STELLANTIS PARTS & SERVICES			Technical Service Bulletin (TSB) Cold Engine Ticking Noise			
REFERENCE:	TSB : 09-001-24 GROUP : 09 - Engine	Date:	January 20, 2024	REVISION:	09-011-22	
VEHICLES AFFECTED:	**2019 - 2024** (DT) Ram 1500 Pickup This bulletin applies to vehicles equipped with a 5.7L V8 Hemi MDS VVT Etorque Engine (Sales Code EZL) and a 5.7L V8 Hemi MDS VVT Engine (Sales Code EZH).		MARKET AN NA SA EE	PPLICABILITY:		
CUSTOMER SYMPTOM:	The customer may describe a ticking noise from the exhaust manifold location(s) when cold.					
CAUSE:	Exhaust manifold.

This bulletin supersedes Technical Service Bulletin (TSB) 09-011-22, date of issue September 03, 2022, which should be removed from your files. All revisions are highlighted with **asterisks** and include new vehicle years.

Fig. 1
Exhaust Manifold Area

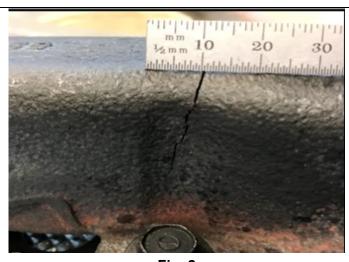
- 1. Start the vehicle cold. Listen for ticking noise that stops after engine is warmed up.
- 2. Shut engine off and allow engine to cool.
- 3. Remove exhaust manifold heat shield(s) from the side that is suspect to be leaking for manifold inspection .
- 4. Re-start cold engine and listen for noise source at exhaust manifold area.
- 5. Visually inspect for a cracked manifold and confirm it is not a casting parting line or casting fin in location shown. Fig. 1

1- Manifold Crack Area

6. If a cracked manifold is found, replace the exhaust manifold(s) that are cracked. Refer to the detailed service procedures available in DealerCONNECT>Service Library under: 09 - Engine, 5.7L / Manifolds / Manifold, Exhaust / Removal and Installation.
